OBJECT: Precautions for stoves model HR100-HRV120-HRV120 STYLE

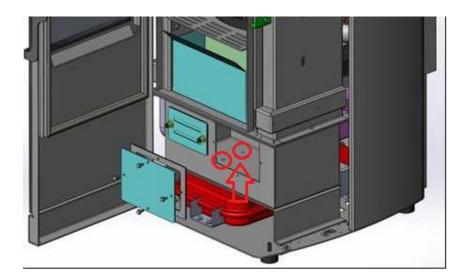
1) Please check if the smoke extractor is rotating into the proper direction (CLOCKWISE direction looking at the smoke extractor frontally). To have access to the smoke extractor, remove the lateral left panel. See picture below.

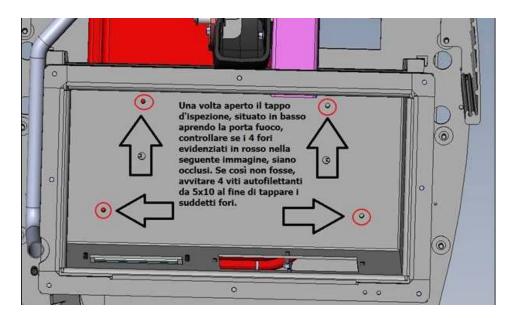
2a) Open the door of the boiler and open the inspection cap as show in the picture below;

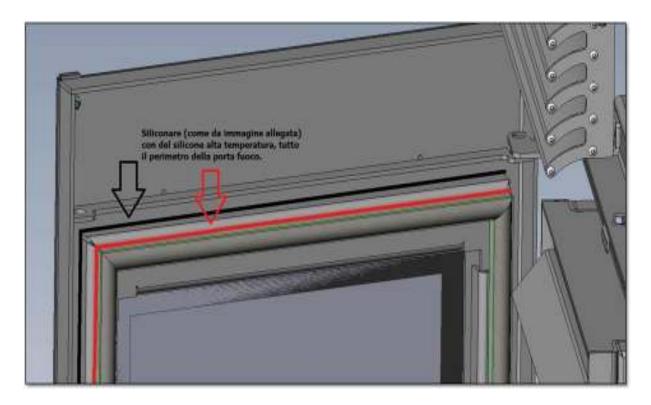
2b) Check inside the inspection chamber placed under the stove body if the 4 holes have been properly sealed. If not, proceed with seraling these holes with 4 self-tapping screws 5x10 as indicated in the picture below;
